ADDENDUM No. 3

REQUEST FOR QUOTATIONS No.:	1220-040-2024-045
TITLE:	TENANT IMPROVEMENTS OF BRIDGEVIEW CHILDCARE CENTRE
ADDENDUM ISSUE DATE:	SEPTEMBER 5, 2024
CLOSING DATE:	PREFER TO RECEIVE SUBMISSION ON OR BEFORE SEPTEMBER 11, 2024

Drawing No. **S201**

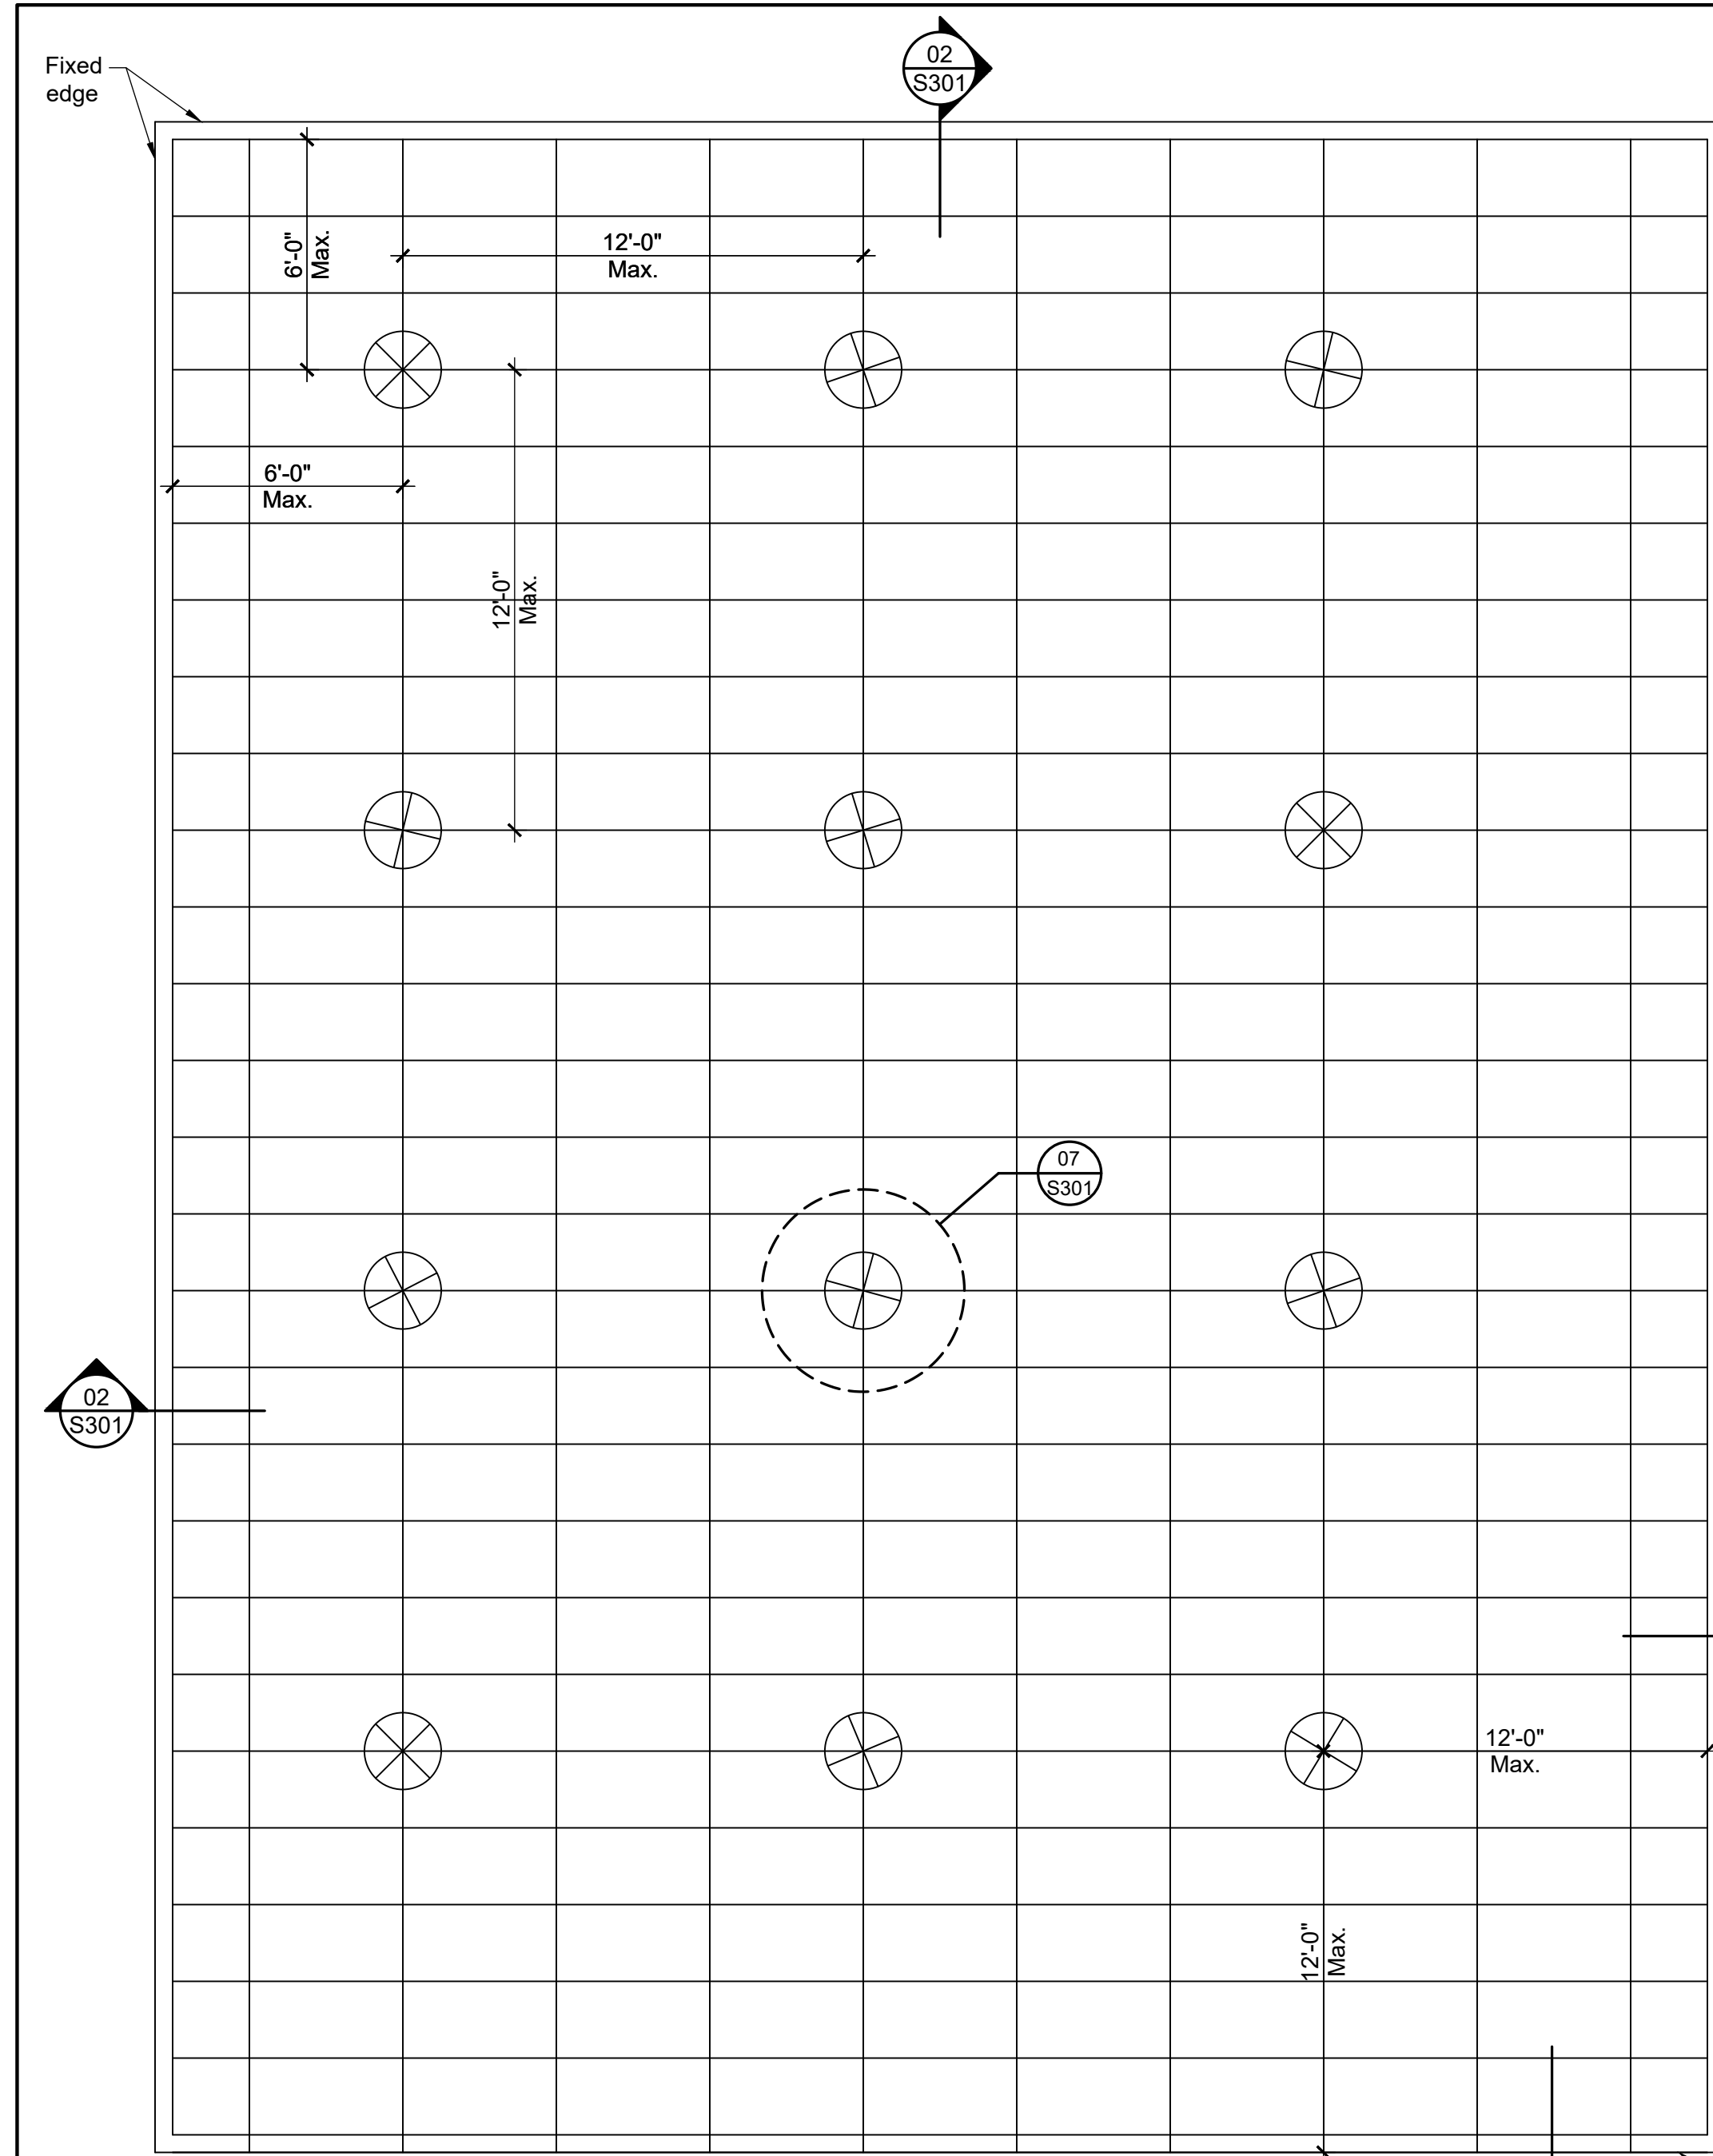
Q1. Drawing S 201 shows the Beam Schedule / please identify the location of Beam B5 / not shown plan?

Q2. Clarify what the symbols 3 S and 4 S represent as key notes do not identify these symbols.

A1. Beam B5 is located along Gridline H between 1 & 2.

A2. These reference the number of supporting studs underneath a load bearing element (beam) – please refer to item #22 of the structural plan legend on drawing S201.

1 REVISED LIGHTING AND LIFE SAFETY LAYOUT
E2.0

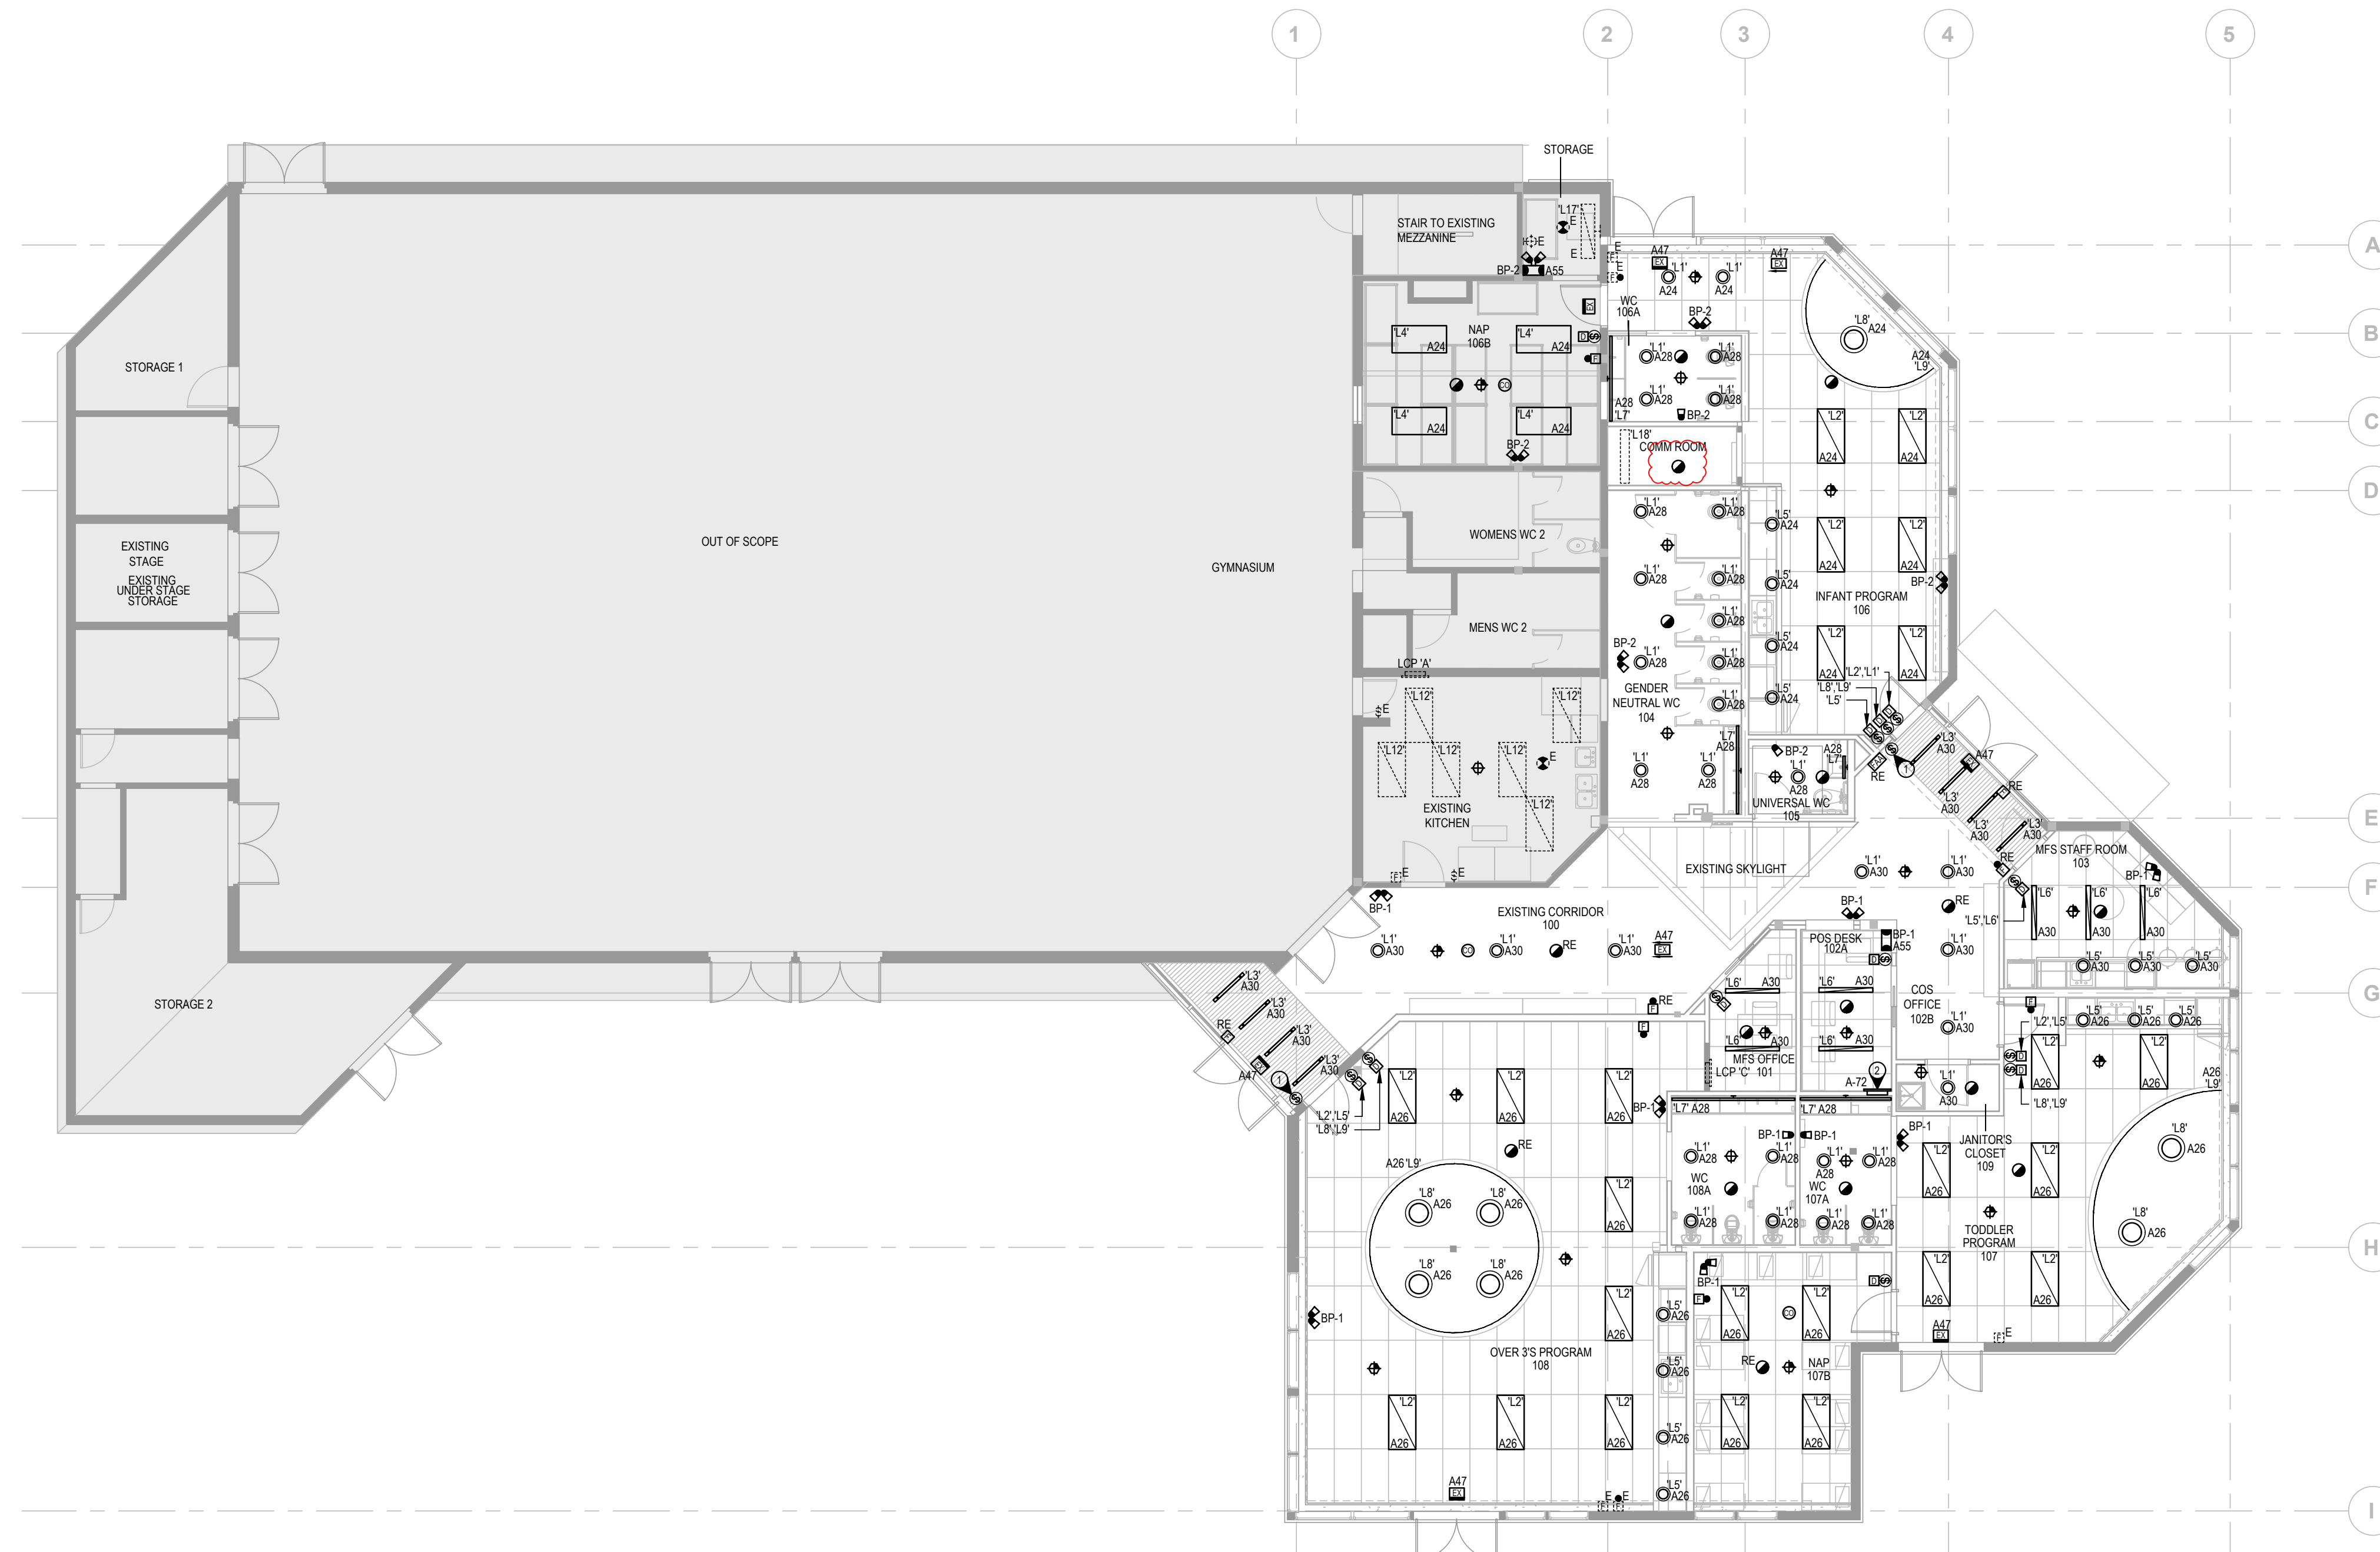
2. Sheet E1.0 & E2.0 – Existing and Revised Lighting and Life Safety Layouts

.1 Replace existing heat detector with new smoke detector as required.

6 ACCESS CONTROL - ELECTRIC STRIKE INFRASTRUCTURE
E3.0 NTS

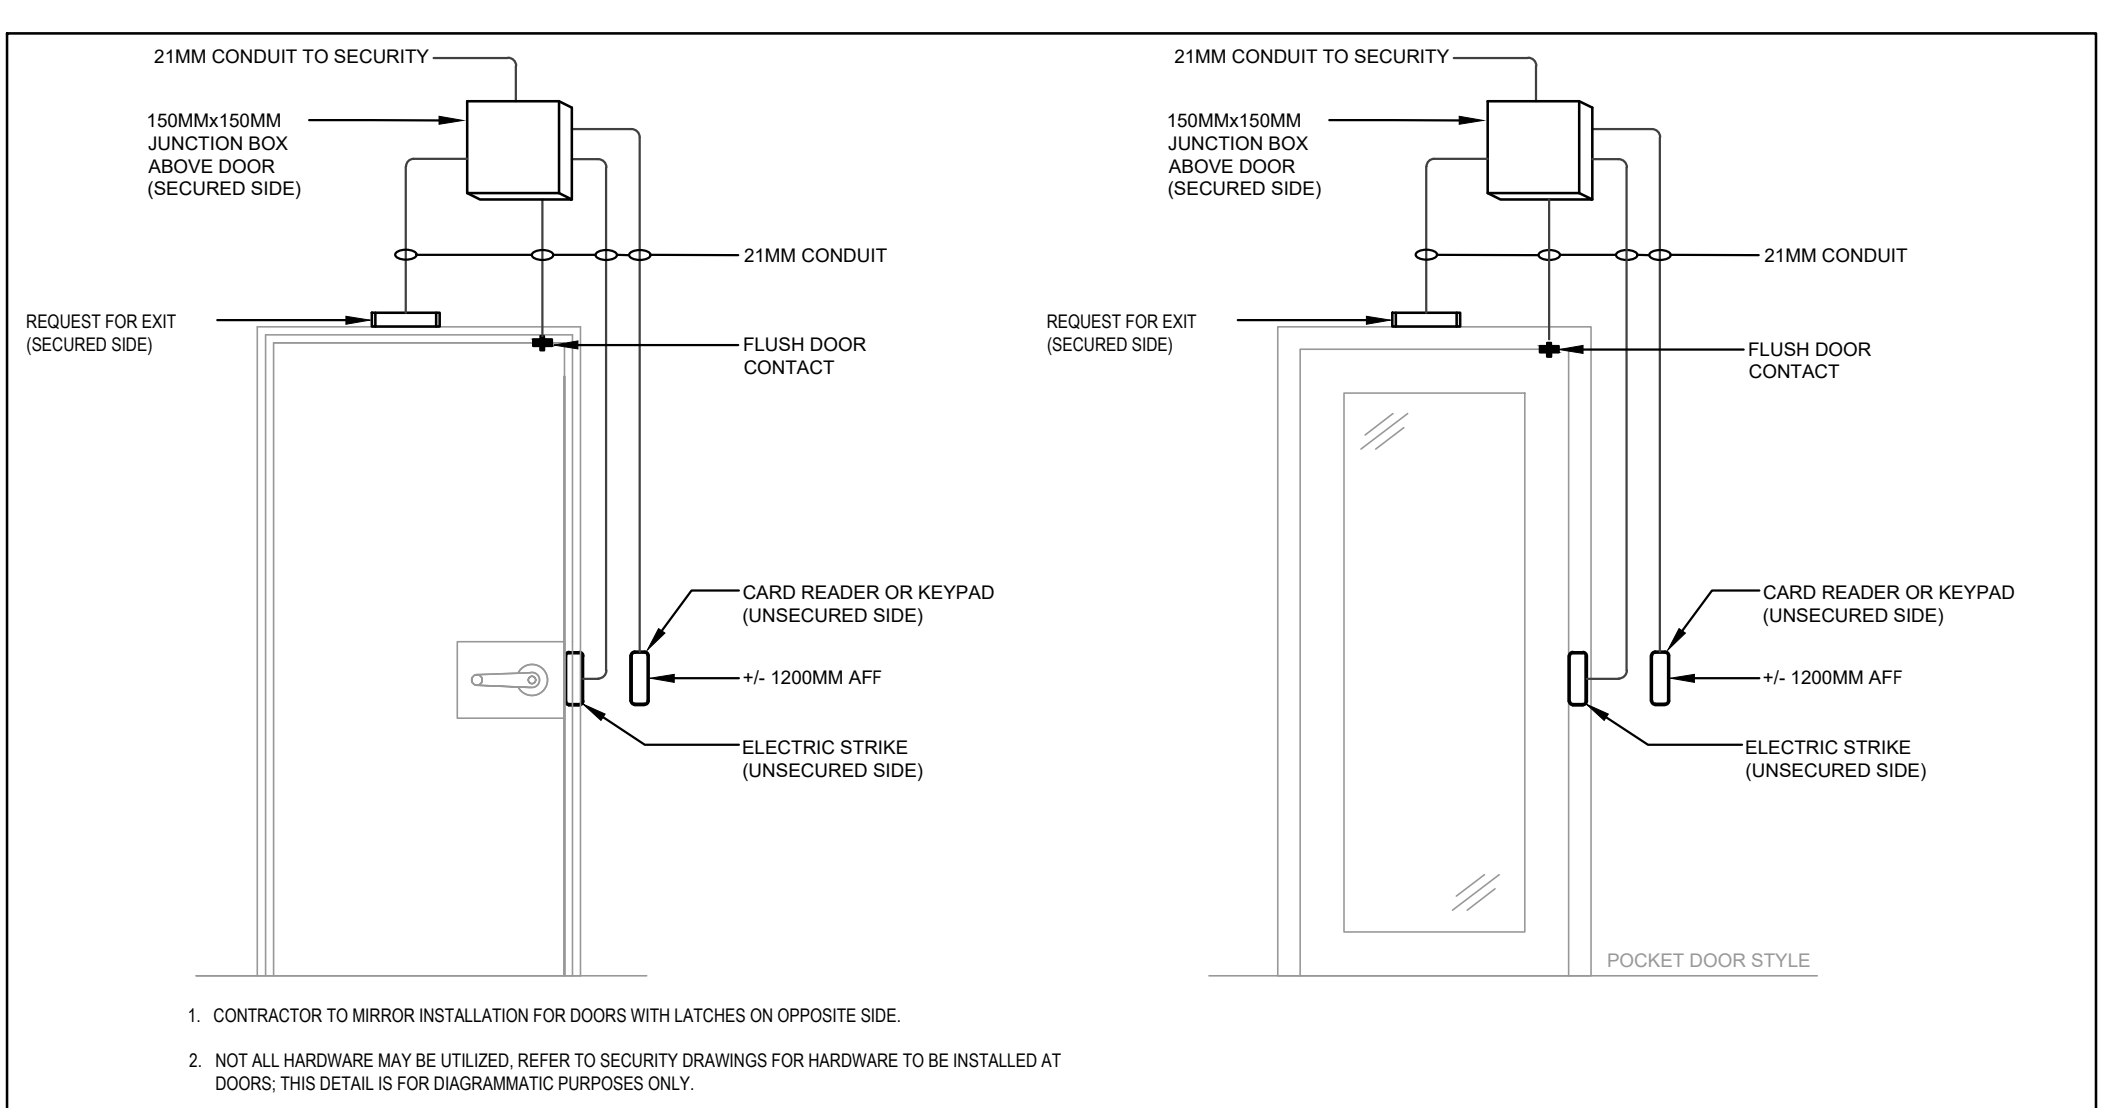
5. Sheet E3.0 – Details and schedules

- .1 Revised detail drawing for electric strike for pocket door.
- .2 Added detail drawing for ADO infrastructure.
